# UNITED STATES PATENT AND TRADEMARK OFFICE

10/763,961

<b>Office Action Summary</b>	<b>Application No.</b> 10/763,961	<b>Applicant(s)</b> BEGER ET AL.	
	<b>Examiner</b> Anu Ramana	<b>Art Unit</b> 3733

## **DETAILED ACTION**

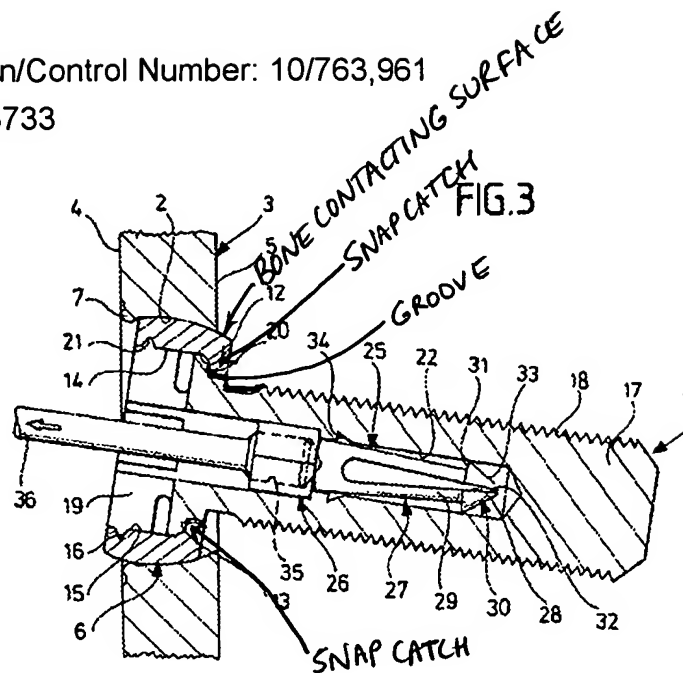
Applicants' further argue that the Eckhof et al. clamping element 6 does not have snap catches protruding from a bone contacting surface. This is not found to be persuasive as shown in marked up Figure 3 on the following page.

Further, snap catches of clamping element 6 engage a circumferential groove or "furrow" below the screw head as shown in marked up Figure 3 above.
